14-AAER-01

**Philips Lighting Comments on Small
Diameter Directional Lamp and Light
Emitting Diode (LED) Lamps**

CA Title 20 inputs (Omnidirectional Lamps)

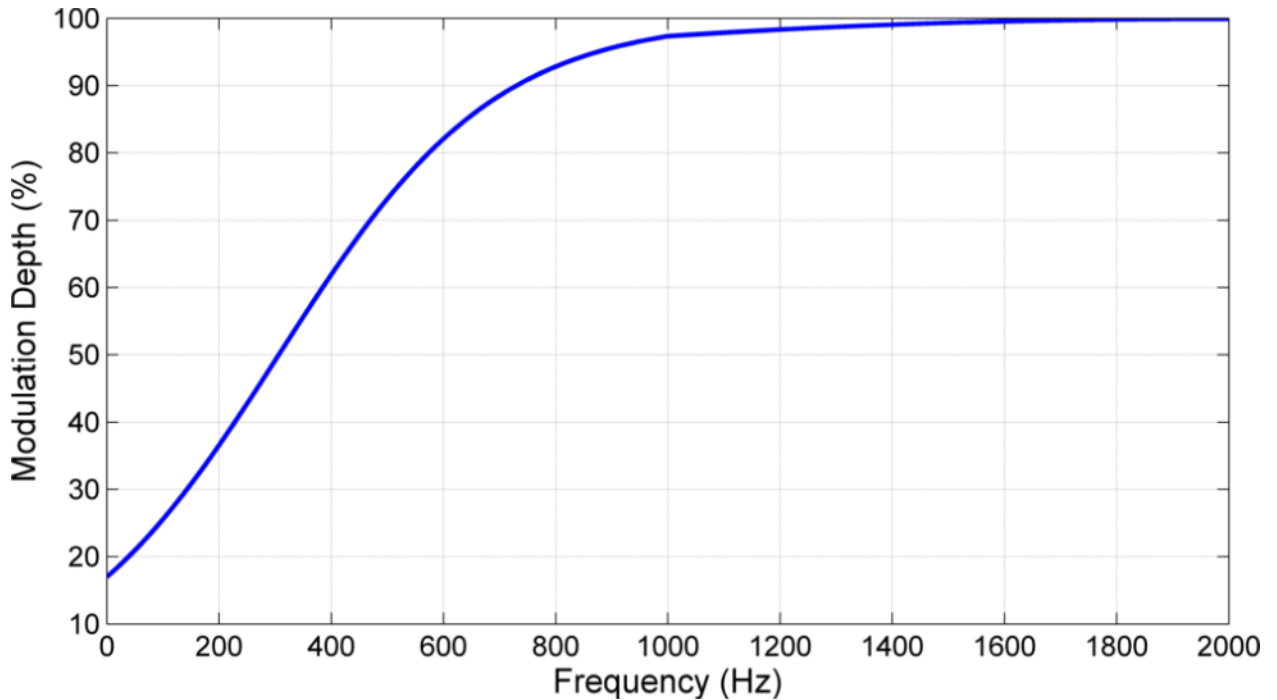
The title 20 specification on flicker is overly restrictive for some frequencies and too lax for others. It states:

“Dimmer controls that can directly control lamps shall provide electrical outputs to lamps for reduced flicker operation through the dimming range so that the light output has an amplitude modulation of less than 30 percent for frequencies less than 200 Hz without causing premature lamp failure.”

This specification makes no allowance for the dependence of human flicker sensitivity either on frequency or on wave shape. For sine wave modulation, the visibility threshold for stroboscopic effects¹, expressed in terms of modulation depth, is shown in the figure below. At a particular frequency, modulation depths above the curve can be detected by most people. Below the curve, they are not detected by most people. The threshold changes for different wave shapes, in a way that depends on the Fourier components of the light output waveform. A full Fourier approach would take account of both frequency and wave shape effects². Sensitivity to flicker also depends on the application. Flicker in outdoor street lighting or in stairwells is more tolerated than in indoor offices, for instance. Therefore, a curve of *acceptability* may be above the *visibility threshold* curve. Different curves may be needed for different applications.

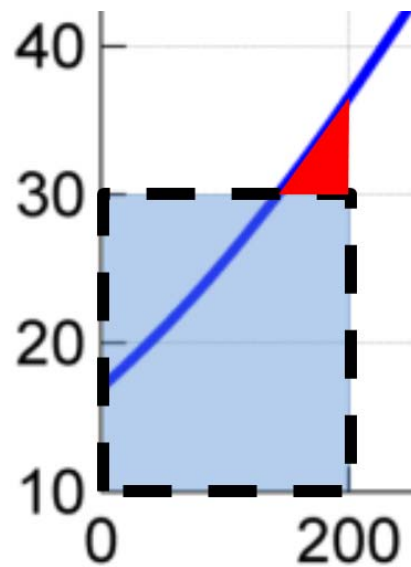
Zooming in on the region from 0 to 200 Hz in the figure above, the shaded rectangular region with dashed outline represents the conditions allowed by the Title 20 specification. The red triangle is forbidden by the Title 20 specification, but flicker in this region is not visible to most observers. Title 20, as a MINIMUM specification, should not exclude acceptable regions where flicker is not even be detected.

The Title 20 specification does a poor job of defining acceptable flicker levels. Specifications on flicker should wait until the experts (in IEEE and in IEC) conclude their work on this topic and produce a solid standard.

If CEC is unwilling to remove the flicker specification and wait for agreement in standards organizations, then CEC should at the very least modify the present specification to allow use of the acceptable flicker region denoted by the red triangle in the figure above. We suggest modifying the specification to allow flicker in the region shown in the figure below. The specification would then be:
